RFQ/066/17 – Supply of water treatment equipment

Summary of Questions and Answers

Place for Water Treatment System

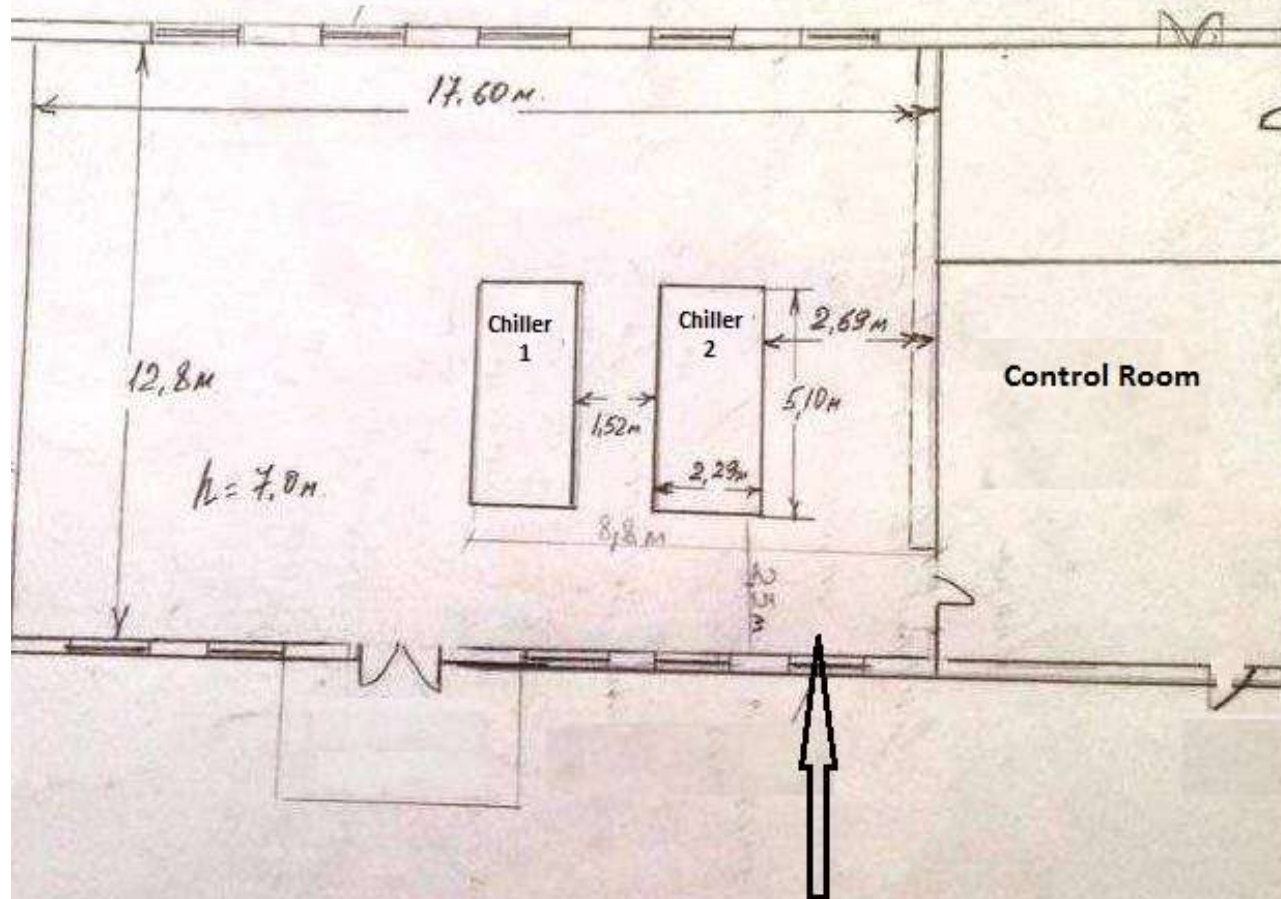
12.	Are the two cooling towers separated? Has each tower its own accumulation tank or do they have a common accumulation tank? Is the tank/tanks recovery is controlled by a mechanical floating valve? If it isn't, how is it made?	Yes, there are two cooling towers and each tower has its basin with floating valve. However, we are planning to install the water treatment system in the machinery room before the chillers, whereas the cooling towers are located outside the building (please see attached drawings). On the other hand, it is expected that the water treatment system will control bleeding as well, when needed.
